2947 EASTLAKE

2947 Eastlake Ave E, Seattle WA

8.0 EDG SUMMARY

8.0 ITEMIZED RESPONSE TO EDG

EAST UNIT VENTILATION - SECTION DETAIL

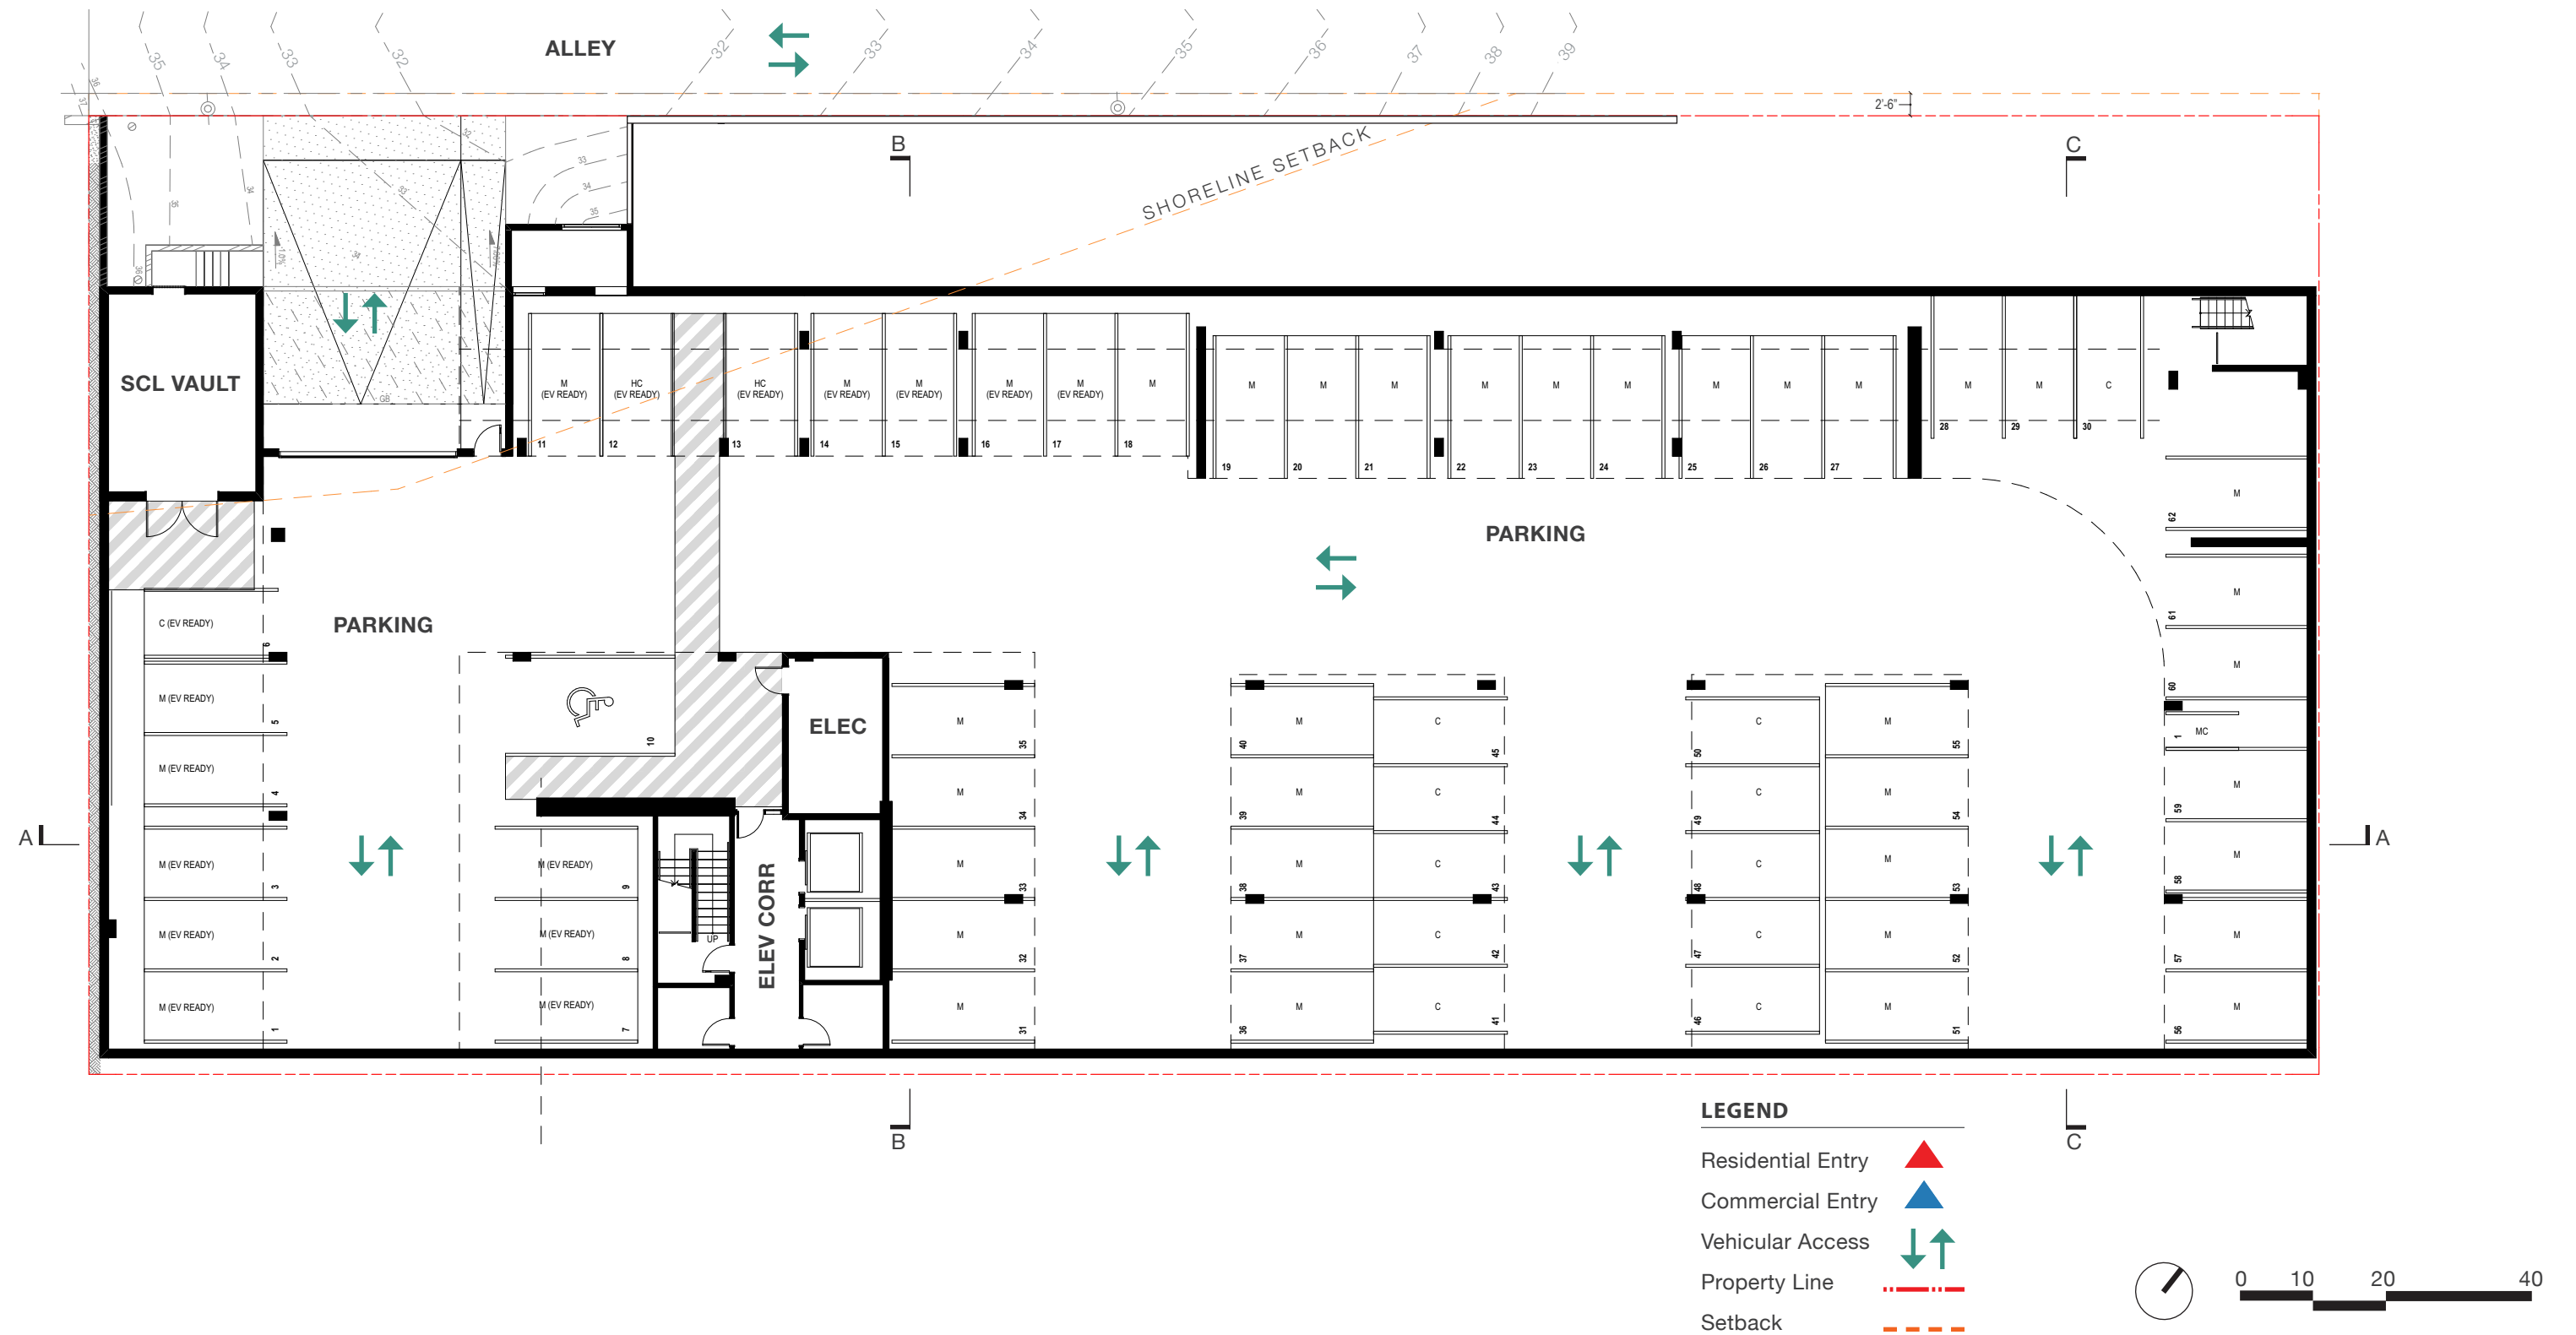
6b b) The Board stated that exterior vents should be included on the drawings for Design Recommendation review, and that vents should be flush and color-matched on all elevations. (DC2-C, DC4-A)

Response:
 For the east facing units along Eastlake Ave E, the mechanical venting for levels 2-4 will route horizontally to the exterior. The fifth level venting will route vertically to the roof. To conceal the horizontal venting, the facade incorporates a wall recess between the non-operable windows on each level. This provides a space for all required vent covers and shrouds to sit behind the perceived exterior wall plane. A demountable metal panel, color matched to the stucco facade, spans the length of the window and conceals the vents. This cavity is open-air and allows ventilation through the top and bottom spaces between the exterior edge of wall and metal panel.

DESIGN DEPARTURE #1

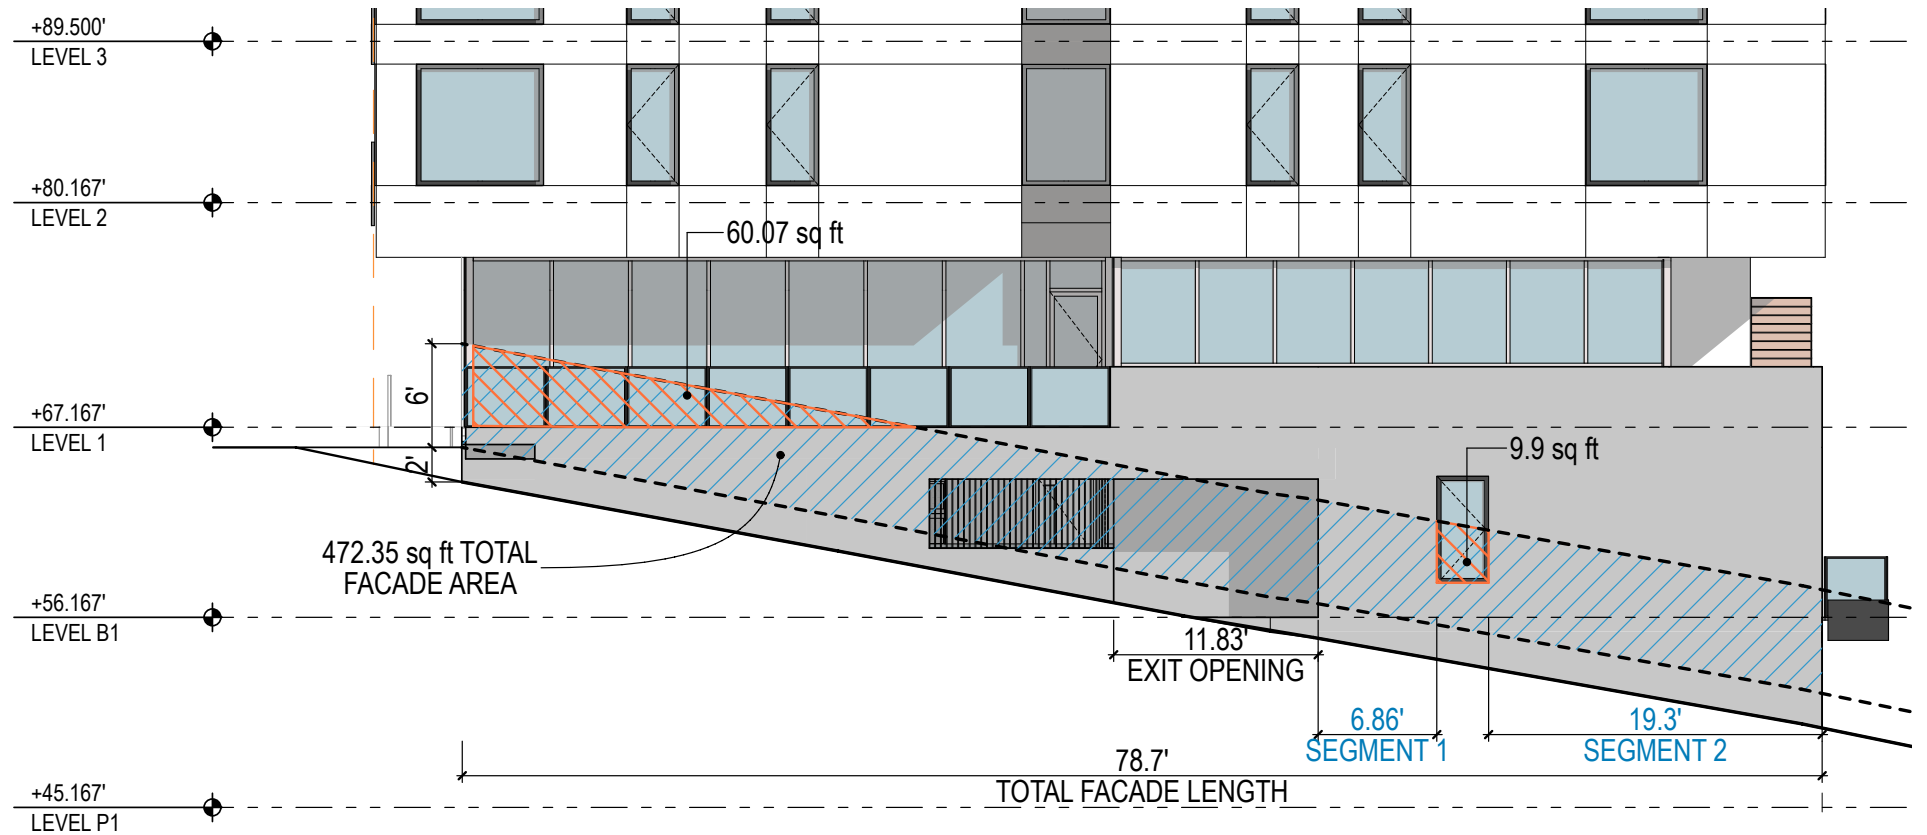
Allow the north facade between 2' and 8' above the sidewalk to be 14.8% transparent, less than the minimum 60% required.

The massing concept of the building is comprised of white stucco boxes floating over a concrete plinth, separated by a street-level swath of storefront glazing and metal panel accents. Due to the steep slope of the site between Eastlake Ave E and the alley, the concrete plinth is significantly exposed along the north facade. With the exception of one residential unit on the west corner, which has been provided with a north-facing window, the uses behind this portion of the facade are back-of-house and would not benefit from additional transparency, which would in turn erode the massing concept. Instead of glazing, relief is provided in the form of the residential exit and bike room entry recess, which includes a custom steel screen and gate assembly. This face of the building is also set back 7'-6" from the inside edge of the sidewalk and the intervening space is landscaped with plantings at a variety of scales, providing a visual screen between pedestrians and the concrete beyond.
